# FAA 7100.41 Design Team Outcomes and Conceptual Procedures

Presentation to: DC Metroplex BWI Community Roundtable

Date: April 24, 2018

# BWI TERPZ/LINSE RNAV SIDs 15L/R (Departures)

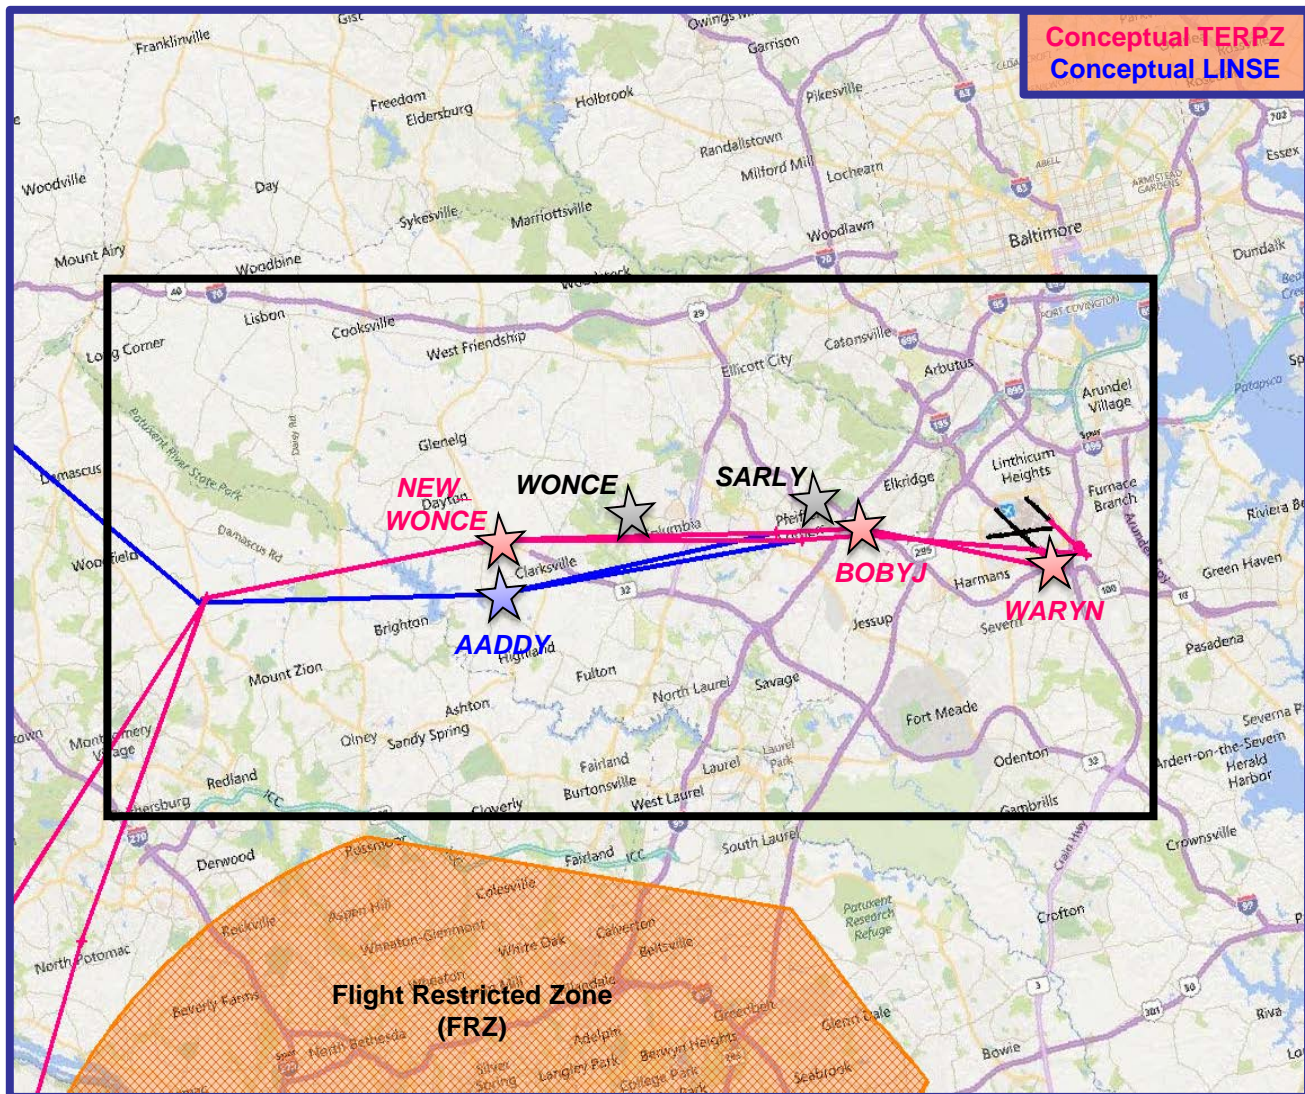
- Runway 15L/R Usage:
  - ✓ 29.1% (37,171 flights/year)
- WARYN added 0.7 nm from end of runway to conform with current voluntary noise abatement procedures (1 DME from BAL VOR)
- Design Requirements
  - ✓ Initial departure off 15R requires a non-standard climb gradient and speed restriction
  - ✓ Still requires industry concurrence and flight standards approval

# BWI TERPZ/LINSE RNAV SIDs 15L/R (Departures)

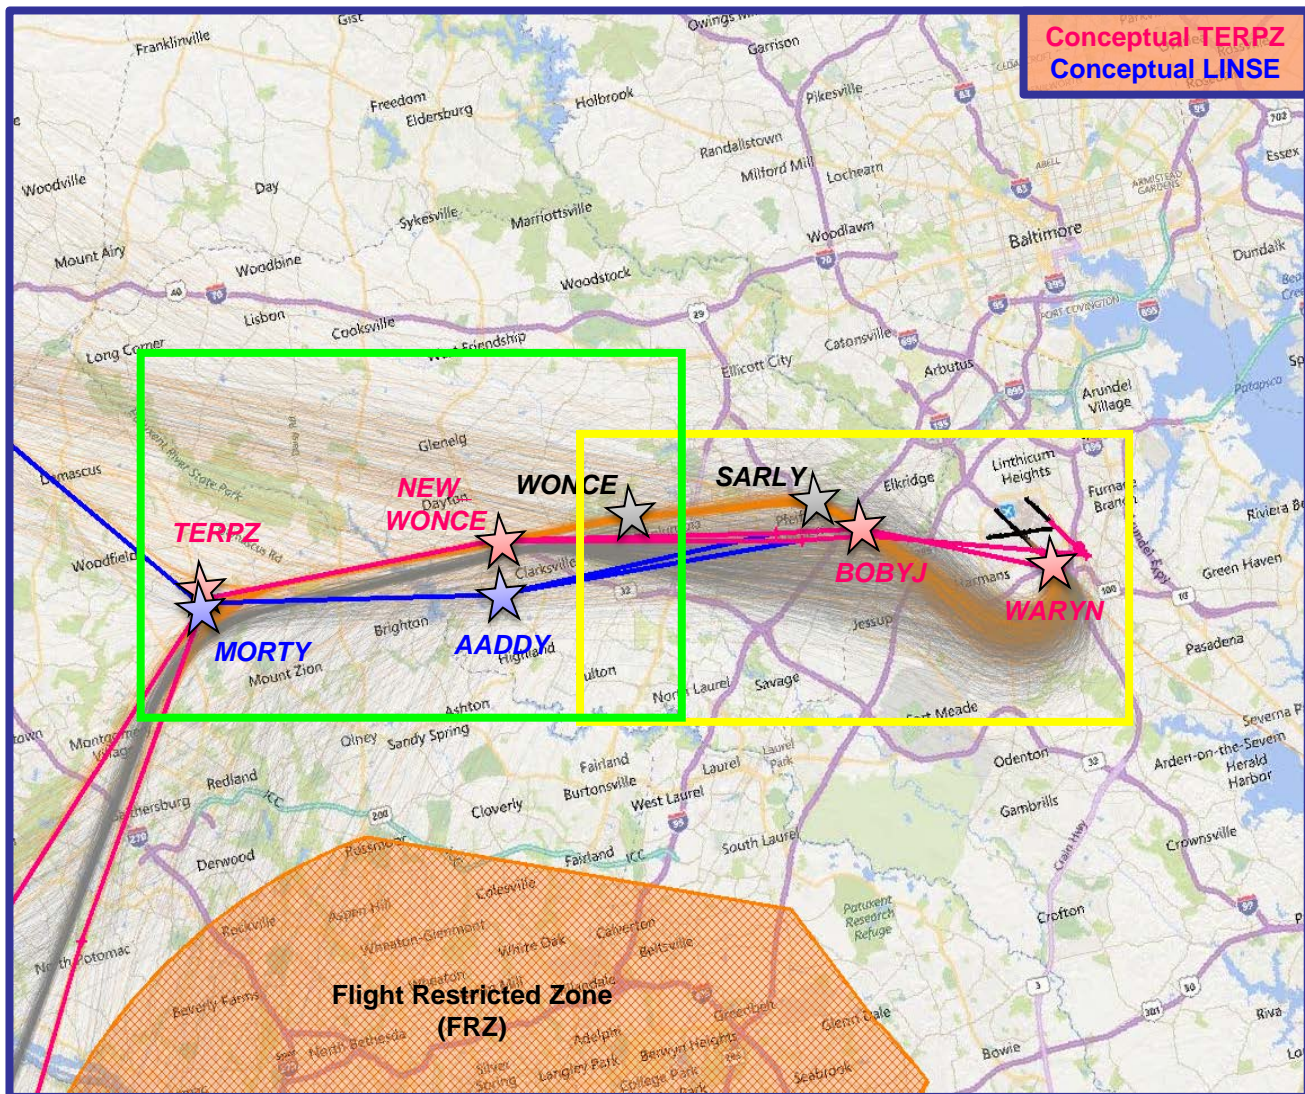
- Runway 15L/R Usage:
  - ✓ 29.1% (37,171 flights/year)
- Pre-Metroplex tracks (Feb 2012)
- **Current tracks (Feb 2017)**
- SARLY removed
- Conceptual design track moved 1.39 nm southeast at BOBYJ
- WONCE moved 3.68 nm west and temporarily named NEW\_WONCE
- AADDY is on the new LINSE procedure to help mimic pre-Metroplex track dispersion
- MORTY is on the new LINSE procedure 0.2 nm southwest of TERPZ

# BWI TERPZ/LINSE RNAV SIDs 28 (Departures)

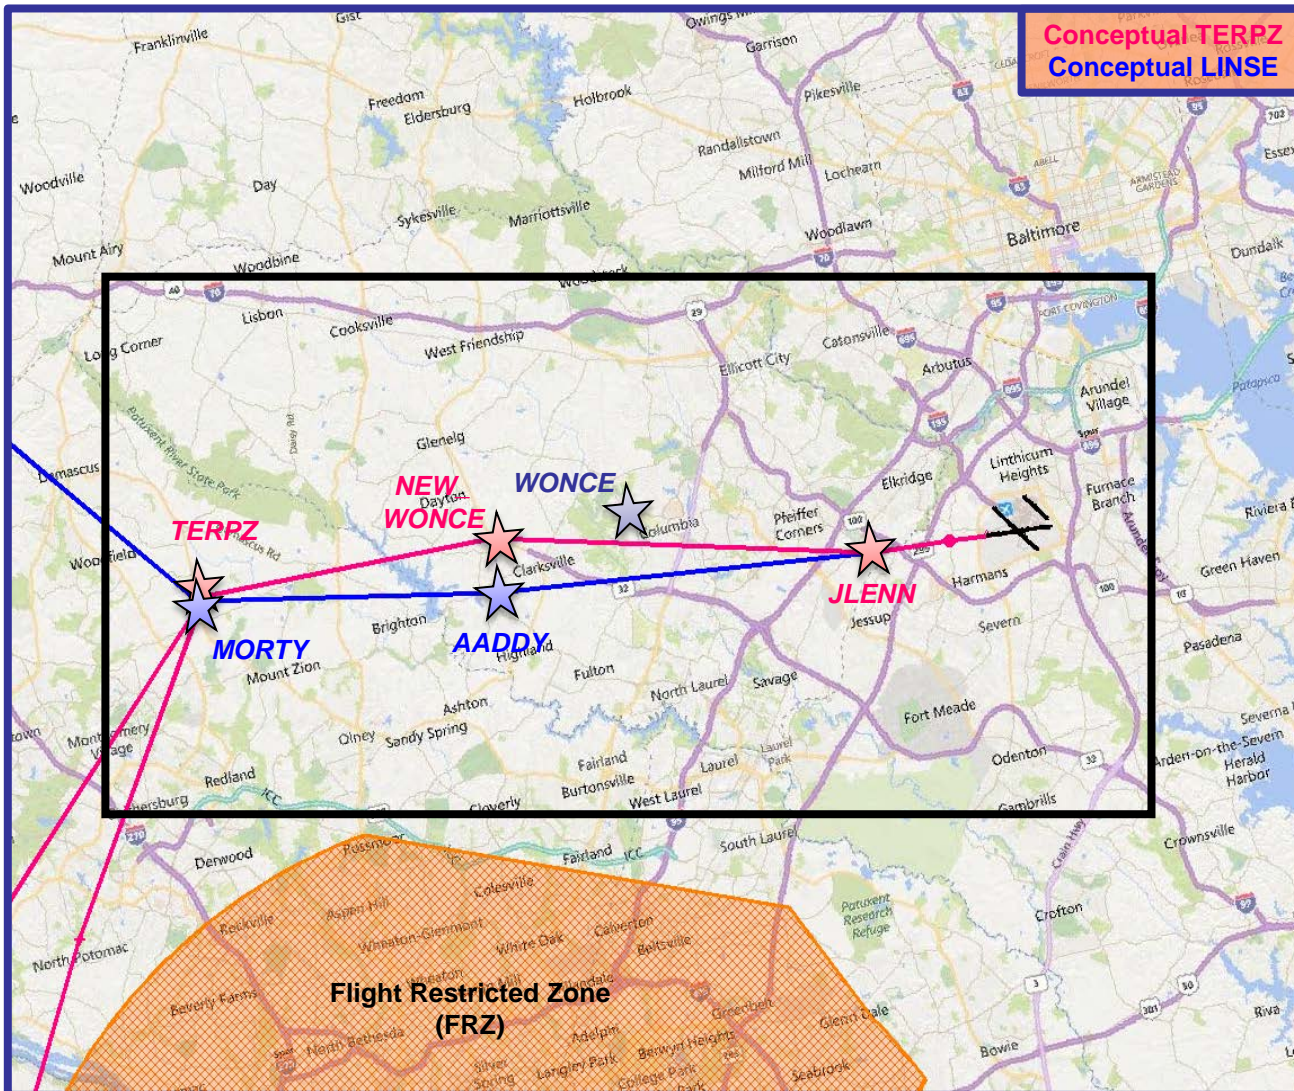
- Runway 28 Usage:
  - ✓ 63.4% (81,023 flights/year)
- **Conceptual TERPZ**  
Serves jet departures to the west and southwest  
Anticipated usage = 74%
- **Conceptual LINSE**  
Serves jet departures to the northwest  
Anticipated usage = 26%
- JLENN added 3 nm from the end of the runway to conform with current voluntary noise abatement procedures
- WONCE moved 3.68 nm west and temporarily named NEW\_WONCE

# BWI TERPZ/LINSE RNAV SIDs 28 (Departures)

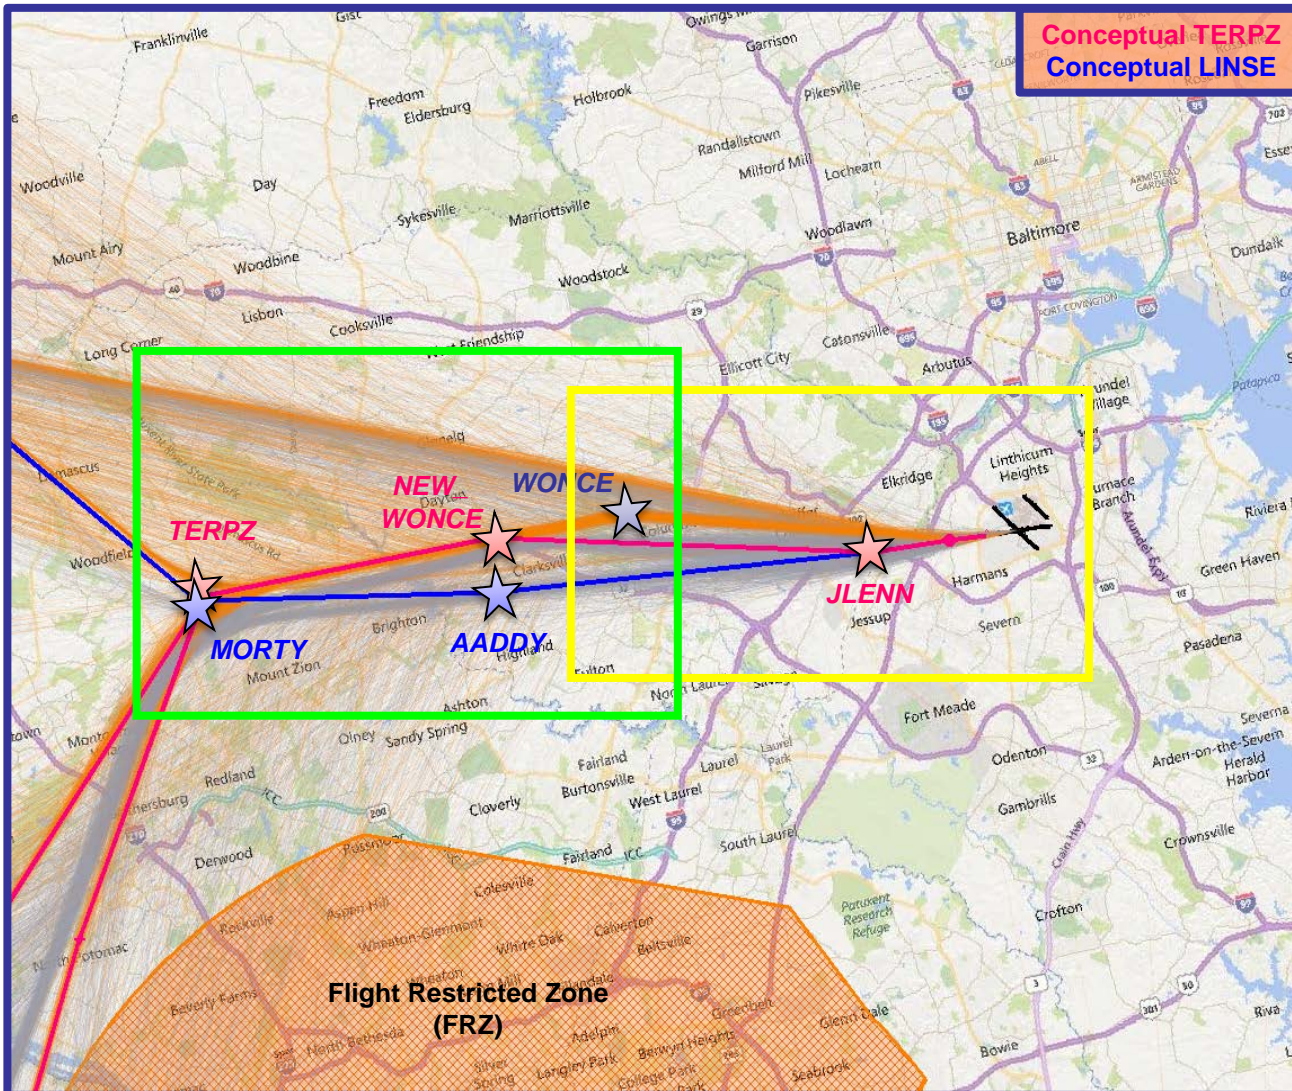
- **Runway 28 Usage:**
  - ✓ 63.4% (81,023 flights/year)
- **Pre-Metroplex tracks (Feb 2012)**
- **Current tracks (Feb 2017)**
- **AADDY** is on the new **LINSE** procedure to help mimic pre-Metroplex track dispersion
- **MORTY** is on the new **LINSE** procedure 0.2 nm southwest of **TERPZ**

# BWI CONLE/FIXET RNAV SID (Departure)

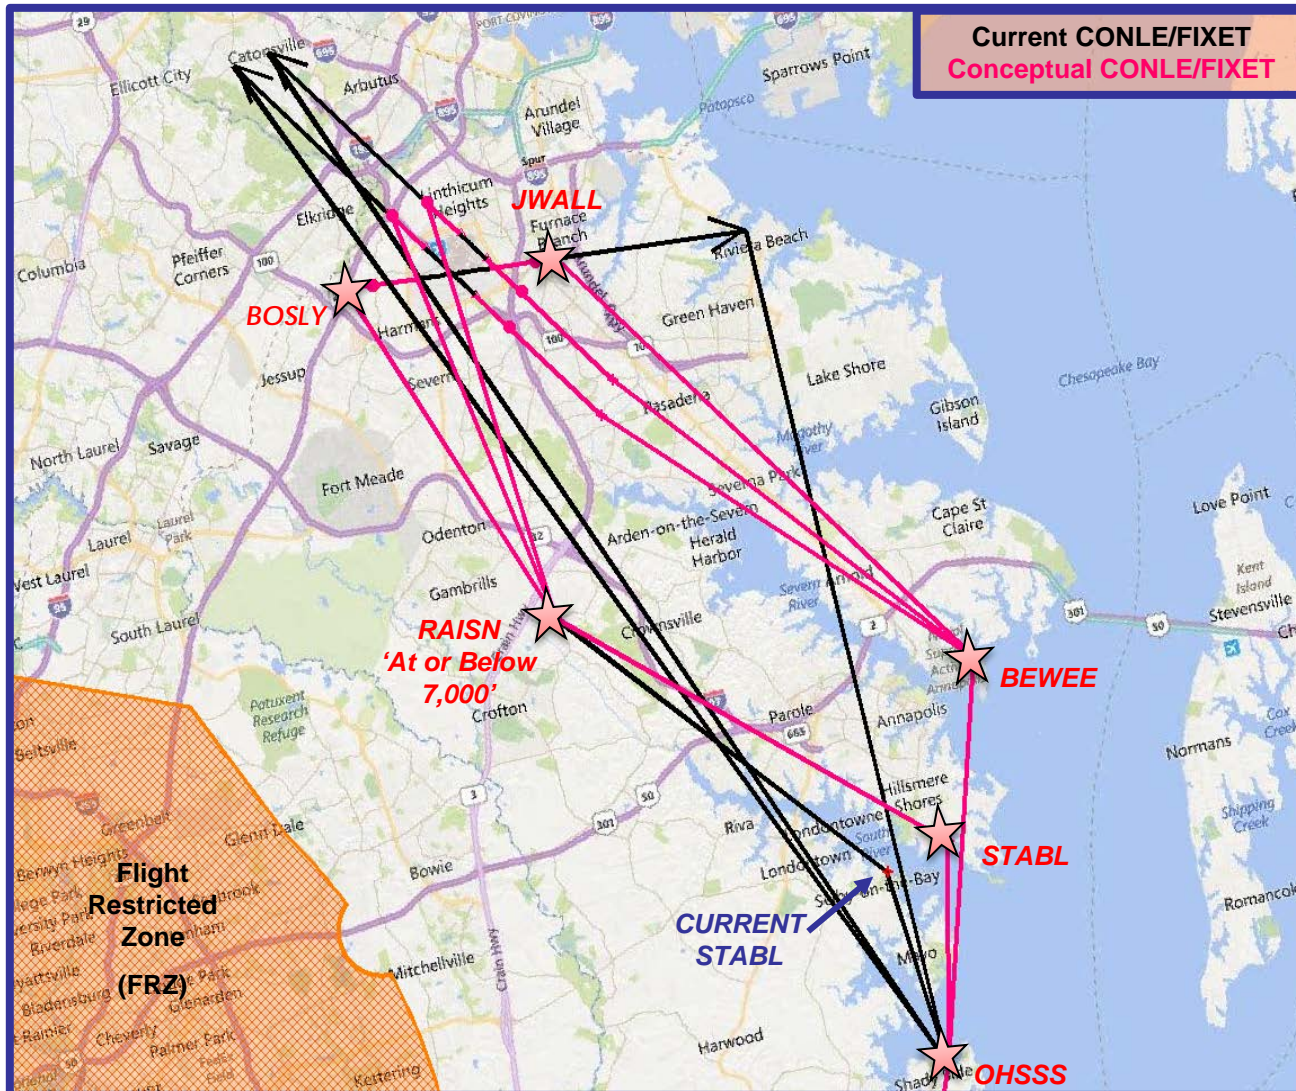
- **Conceptual CONLE**  
Serves jet departures to the south
- **Conceptual FIXET**  
Serves jet departures to the west and southwest during inclement weather events
- **No changes to departures off RWY 15L/R**
  - ✓ Usage: 29.1% (37,171 flights/year)
- **Runway 10 Usage:**
  - ✓ 0.5% (606 flights/year)
- **Runway 10 Changes:**
  - ✓ **Current** – Depart heading 105 with RADAR vectors to OHSS
  - ✓ **Conceptual** - JWALL added 1 nm from end of RWY 10 for conformance with voluntary noise abatement procedures and to utilize climb via
  - ✓ After JWALL procedure goes direct BEWEE, direct OHSS

# BWI CONLE/FIXET RNAV SID (Departure)

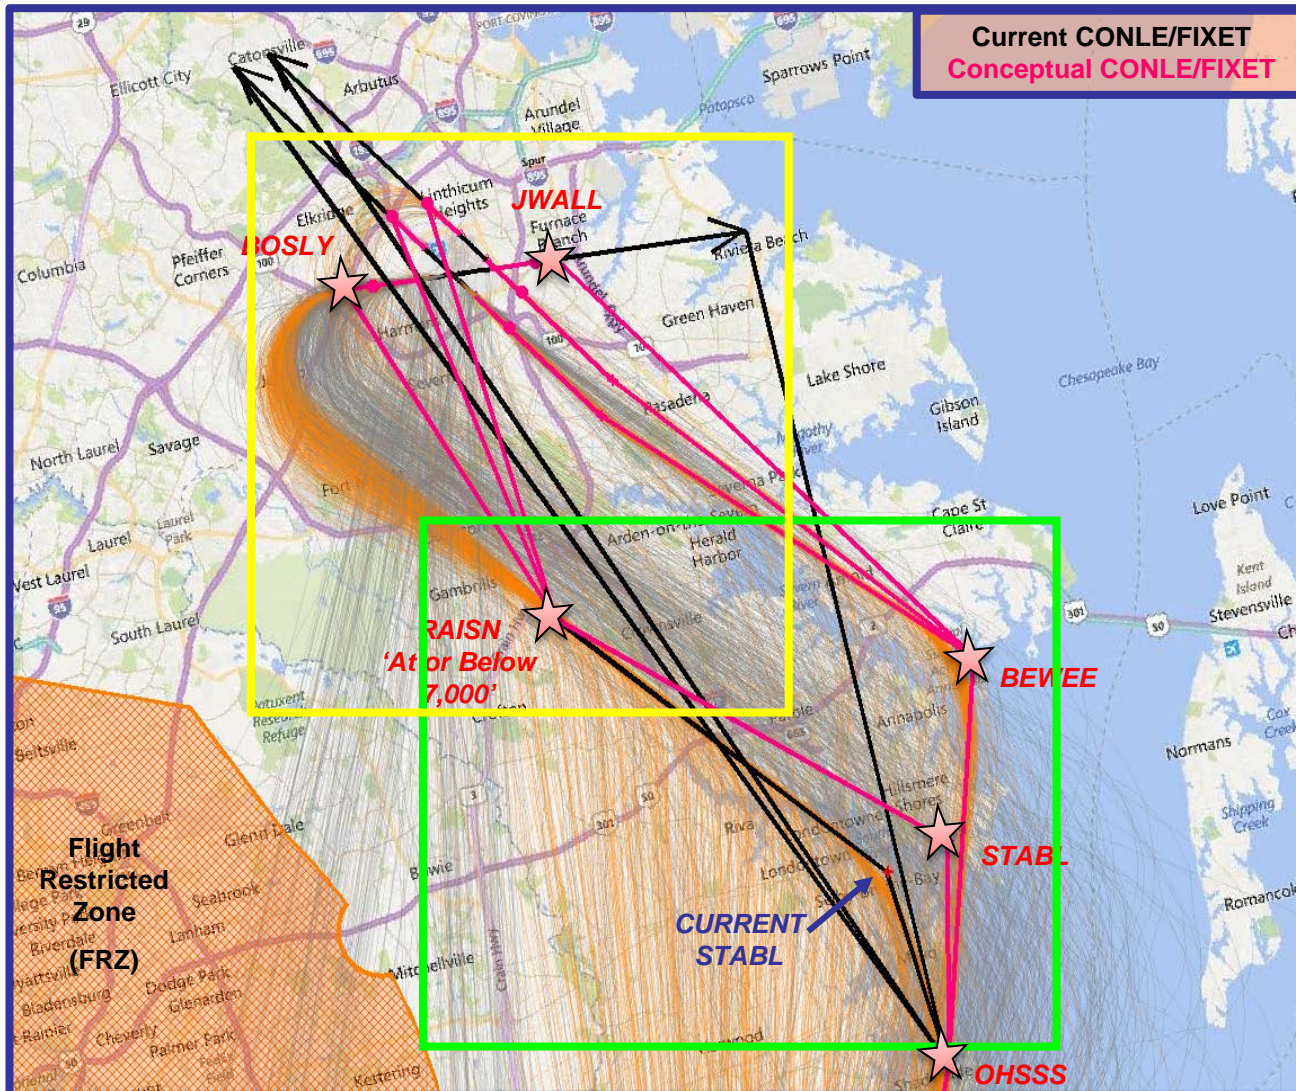
- **Runway 28 Usage:**
  - ✓ 63.4% (81,023 flights/year)
- **Runways 33L/R Usage:**
  - ✓ 7.1% (9,043 flights/year)
- **Runways 28 and 33L/R Changes:**
  - ✓ Altitude restriction 'At or Below 7,000' ft added at RAISN for climb via clearance
  - ✓ STABL moved 1.59 nm east for criteria
- Pre-Metroplex tracks (Feb 2012)
- **Current tracks (Feb 2017)**

# T-Route 356

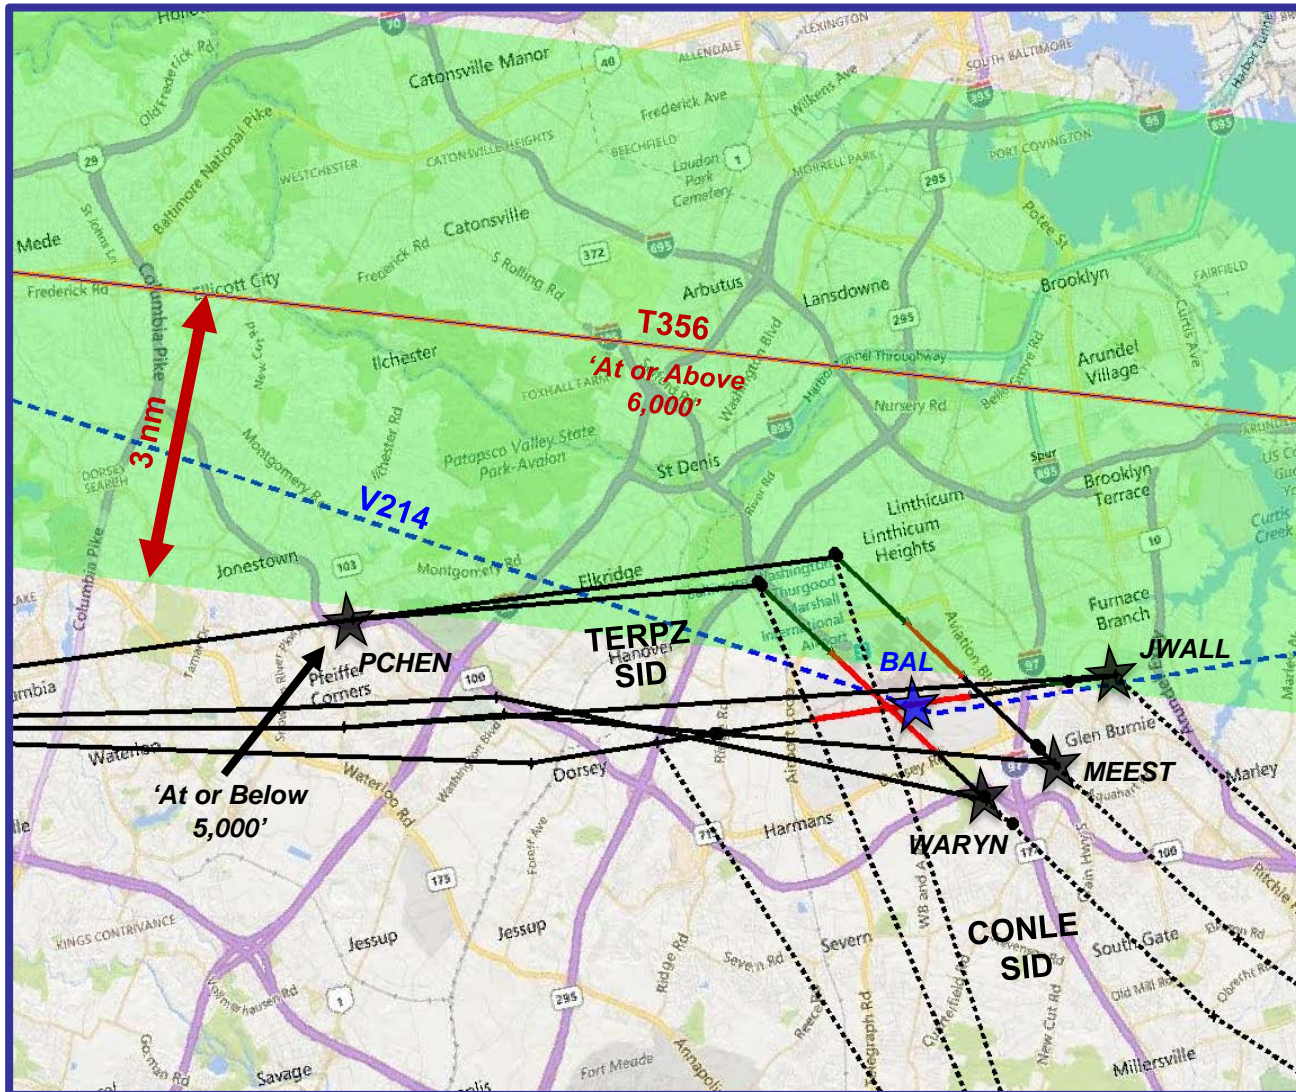
- T356 will allow BWI Tower to issue a Climb Via clearance
- Climb Via clearance allows for a pre-determined, repeatable, and efficient climb
- Currently, Runway 33L/R departures climb to 4,000 ft and level off
- Conceptual procedure will allow for a Climb Via clearance to 14,000 ft
